March 6, 2018

Re: Comments on Zeiss Innovation Center Supplemental Mitigated Negative Declaration/Initial Study, PLPA-2017-00025

Figure 2: Proposed Land of The Boulevard Project and Location of Zeiss Project

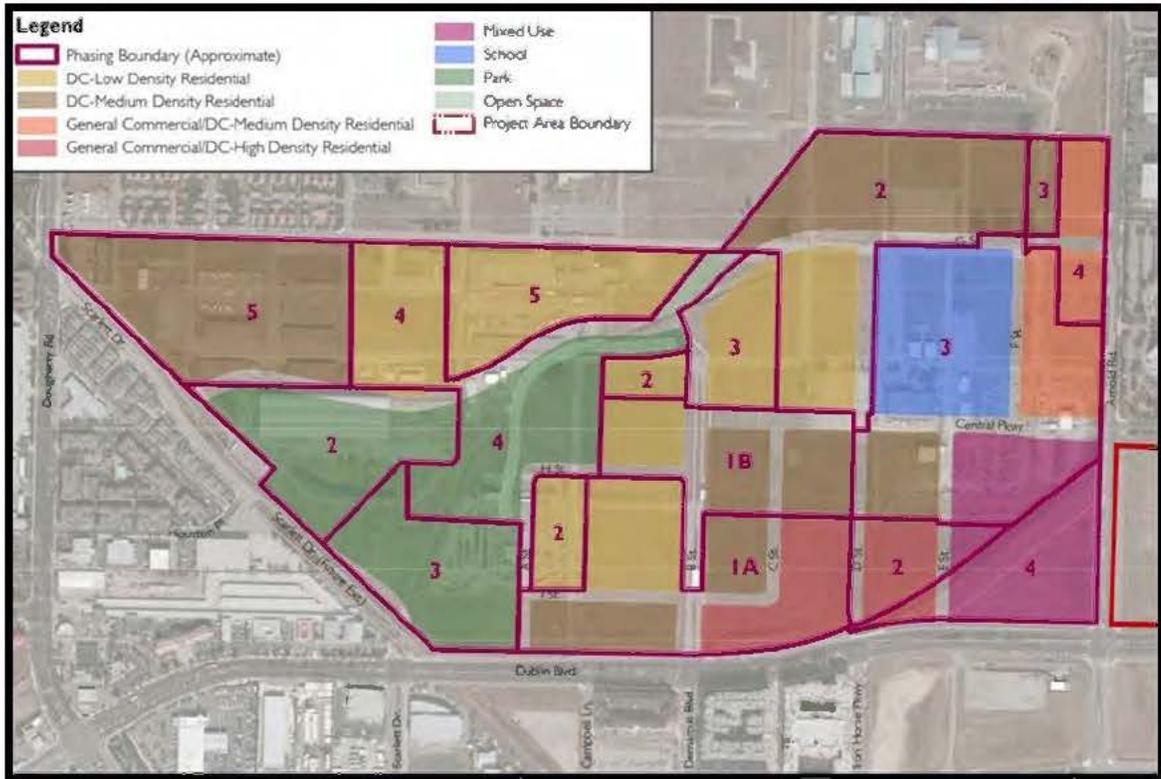
None of these sensitive receptors is mentioned in the SMND or analyzed, but each constitutes a changed circumstance that may result in a significant impact as a result of the Project exposing these sensitive receptors to air pollution. Because these changed circumstances may result in a significant impact, an EIR is required. A Health Risks Assessment must be prepared as part of the EIR to analyze the Project's potential impacts on these nearby sensitive receptors.

An EIR must be prepared to analyze the air quality impacts from the construction and operation of the Project on the residents and school children that will occupy the Boulevard project. In addition, an EIR must look at the cumulative air quality impacts of the Project and the Boulevard project together. Clark Supplemental Comment, p. 5.
